TRAILER SUSPENSION SYSTEMS BUSHING TOOL, NARROW

SUBJECT: Modification Procedure

LIT NO: T89009

Figure 2: Rear drive plate modification

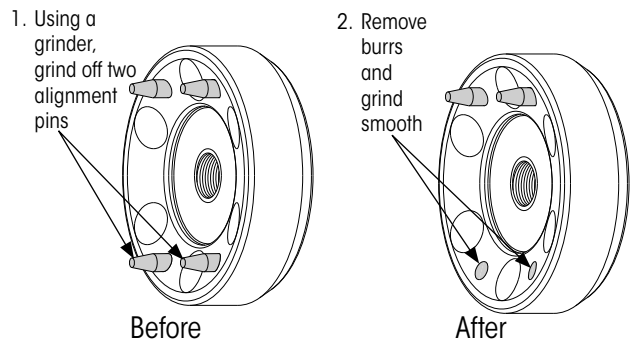
To make a four alignment pin rear drive plate compatible for removal and installation of the QF I bushing, two close spaced pins must be removed, as indicated in Figure 2.

Once removed, the drive plate will continue to be compatible with both narrow TF III and QF I bushings.

Figure 3: QF I spacer washer
(as shown in Hendrickson literature number L427)

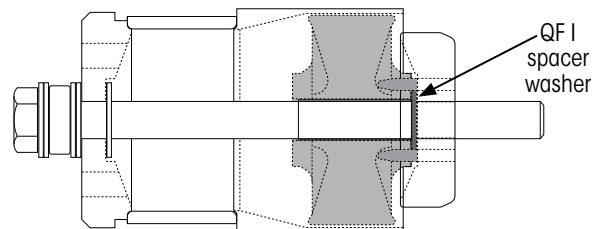
QF I bushing installation, as shown in Figure 3, requires an additional .25 inch thick spacer washer.
